Re: **Docket No. 507 – Application of Homeland Towers, LLC and Cellco Partnership d/b/a Verizon Wireless for a Certificate of Environmental Compatibility and Public Need for the Construction, Maintenance and Operation of a Wireless Telecommunications Facility at 222 Clintonville Road, North Branford, Connecticut**

**SUPPLEMENTAL RESPONSES OF HOMELAND TOWERS LLC
AND CELLCO PARTNERSHIP D/B/A VERIZON WIRELESS
TO SITING COUNCIL PRE-HEARING INTERROGATORIES**

Site #29: St Andrews Church 700MHz modeled at 40'.

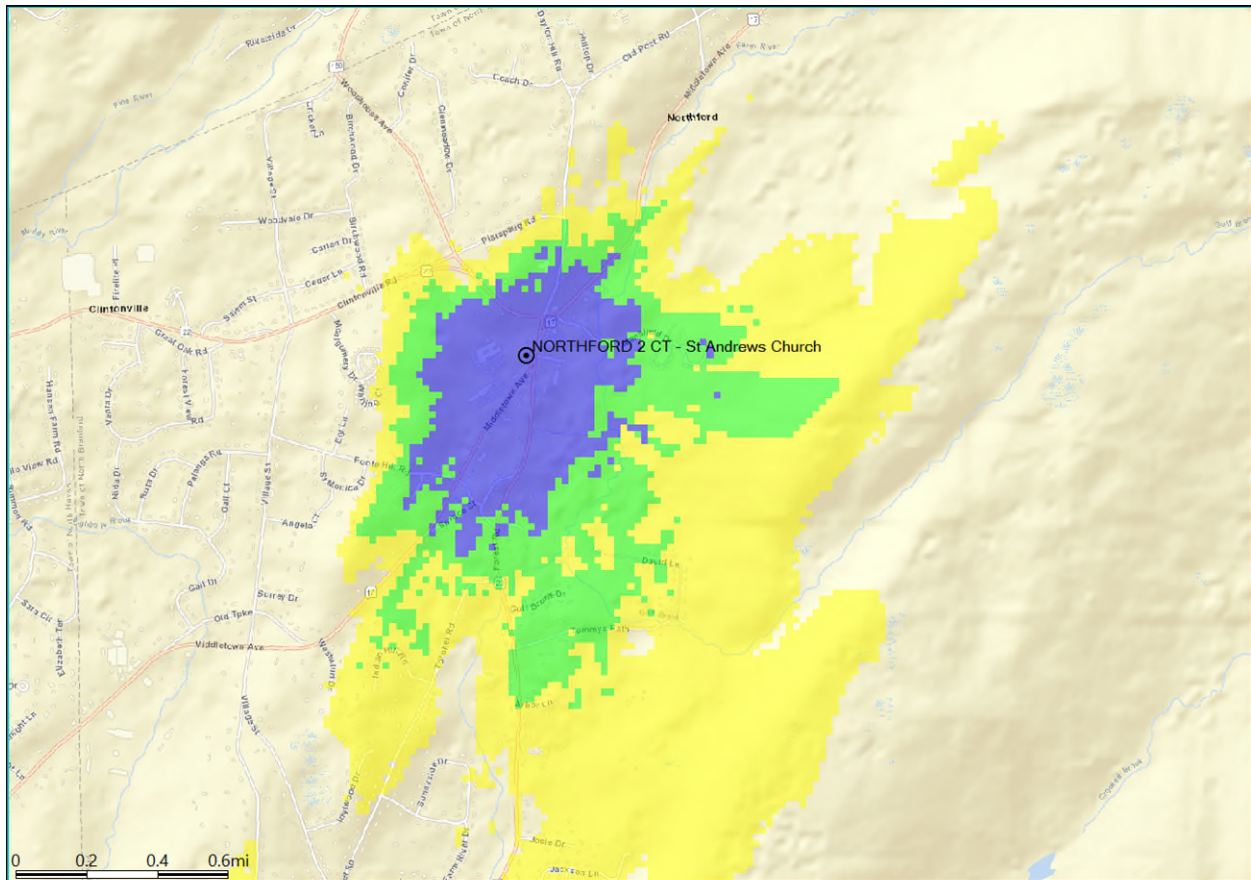
Referencing Application Attachment 8, provide propagation modeling for Site 29 and Site 30. What antenna height was modeled at each location?

The Church covers a much smaller area than the proposed site.
